MANDATORY SERVICE BULLETIN

MSB 42-126/1

MSB 42NG-066/1

Inspection of flap bell crank for cracks, installation of two spacers instead of one long spacer and replacement of early revisions of the affected flap bell crank.

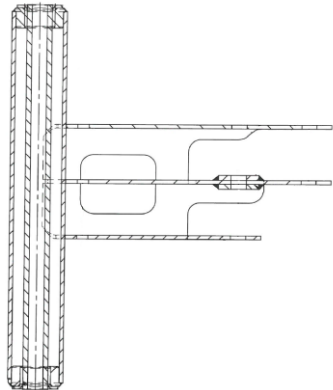
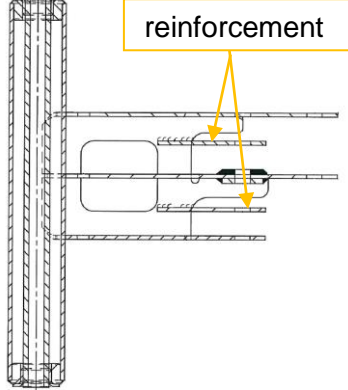
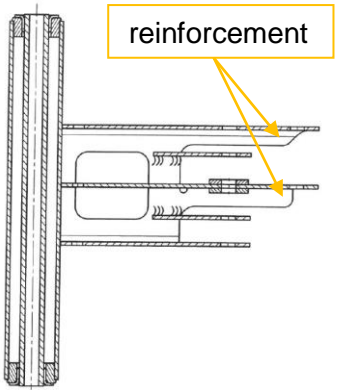
1	Make sure that the Electric Master Switch is switched OFF and pull the flap circuit breaker.
2	Remove the passenger seat in accordance with AMM, section 25-10.
3	Disconnect the flap actuator rod end bearing from the flap bell crank in accordance with AMM, section 27-50.
4	Disconnect the 4 flap pushrods from the flap bell crank.
5	<p>Check which flap bell crank design is installed to the airplane.</p> <div style="display: flex; justify-content: space-around;"> <div style="text-align: center;"> <p>A)</p>  <p>D60-2757-11-00 up to Revision "d"</p> </div> <div style="text-align: center;"> <p>B)</p>  <p>D60-2757-11-00 Revisions "e" and "f"</p> </div> <div style="text-align: center;"> <p>C)</p>  <p>D60-2757-11-00_01</p> </div> </div>

7	<p>If flap bell crank D60-2757-11-00 up to revision “d” is installed:</p> <ul style="list-style-type: none"> Replace the flap bell crank with the improved flap bell crank design D60-2757-11-00_01 in accordance with AMM, Section 27-50. <p>Note: Flap bell crank P/N D60-2757-11-00 up to Rev. “d” was installed in the following airplanes:</p> <p style="padding-left: 40px;">42.004 through 42.082, 42.107, 42.109 through 42.113, 42.AC001 through 42.AC006</p> <p>Note: If necessary, remove the aileron push rods from the aileron bell crank and remove the aileron bell crank to gain better access for removing the flap bell crank. Re-install aileron bell crank and aileron push rods after replacement of flap bell crank.</p>
8	<p>Install the 4 flap pushrods to the flap bell crank.</p>
9	<p>Install the flap actuator to the flap bell crank in accordance with AMM, section 27-50:</p> <ul style="list-style-type: none"> Position the flap actuator rod end bearing between the two spacers DS BU2-10-06-0065-C, which are installed as a replacement for the long single spacer, as shown in the picture below.

If flap bell crank D60-2757-11-00 revision "e" or "f" is installed:

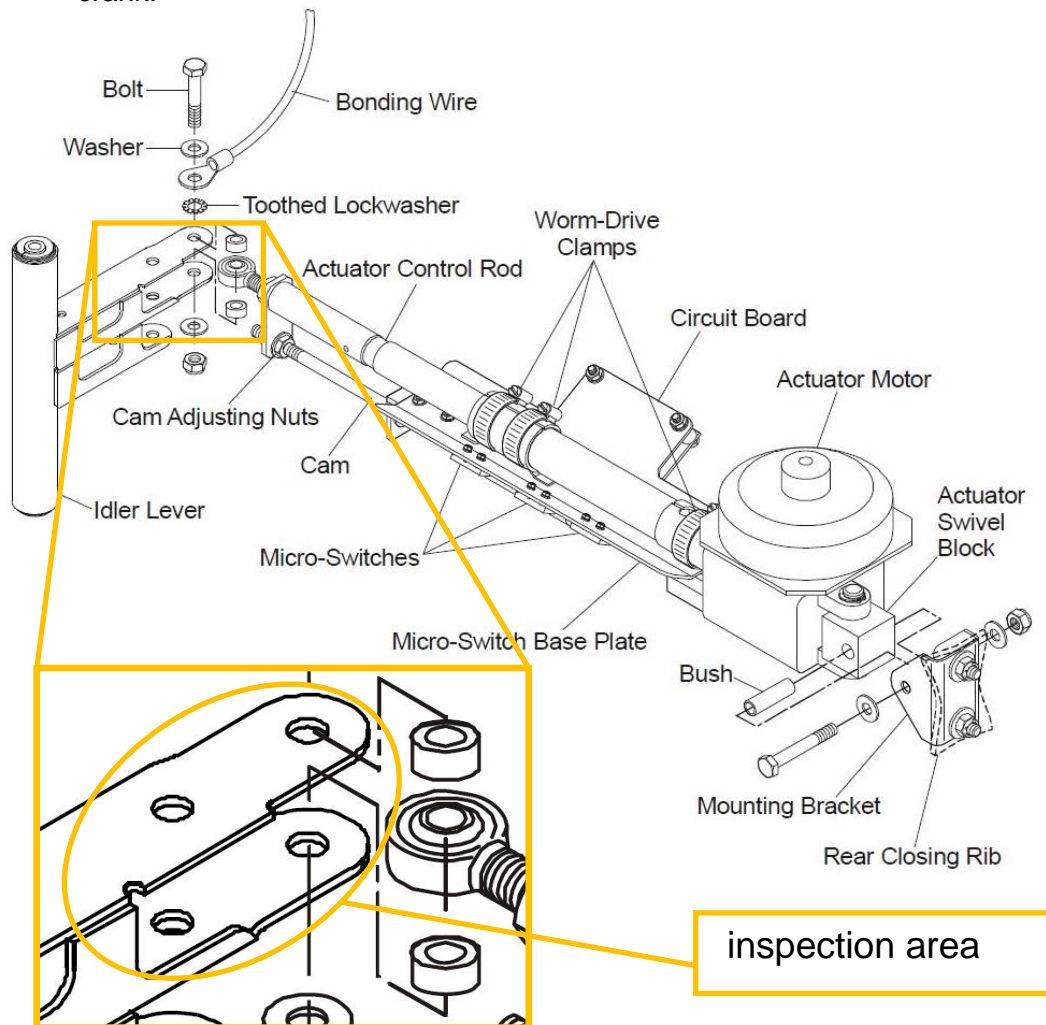
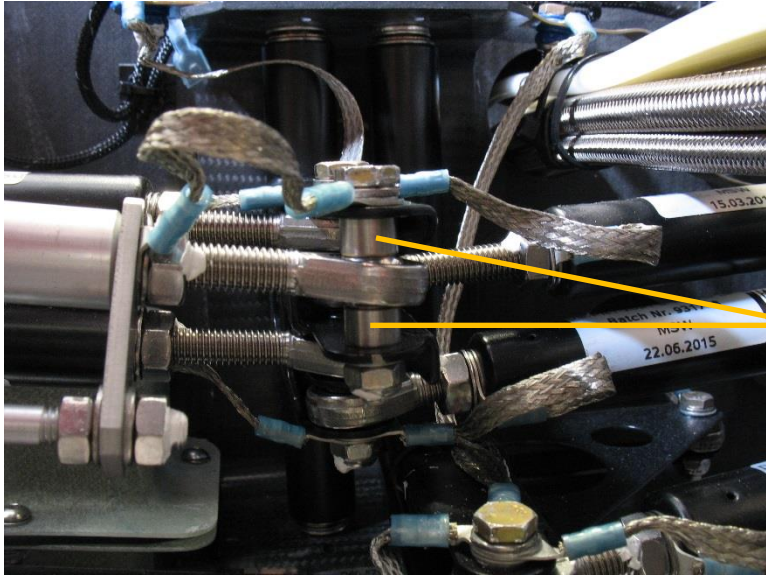
- Examine the flap bell crank for cracks and deformation in the area where the flap pushrods are attached to the flap bell crank as shown in the figure below.
- If cracks or deformation are found, replace the flap bell crank with the improved flap bell crank D60-2757-11-00_01 in accordance with AMM, Section 27-50.

Note: In case of doubt remove the powder coating and carry out dye penetration method to identify possible cracks.

Note: Apply epoxy based zinc phosphate primer and commercial grade 2K PU lacquer to areas where the powder coating has been removed or has been damaged.
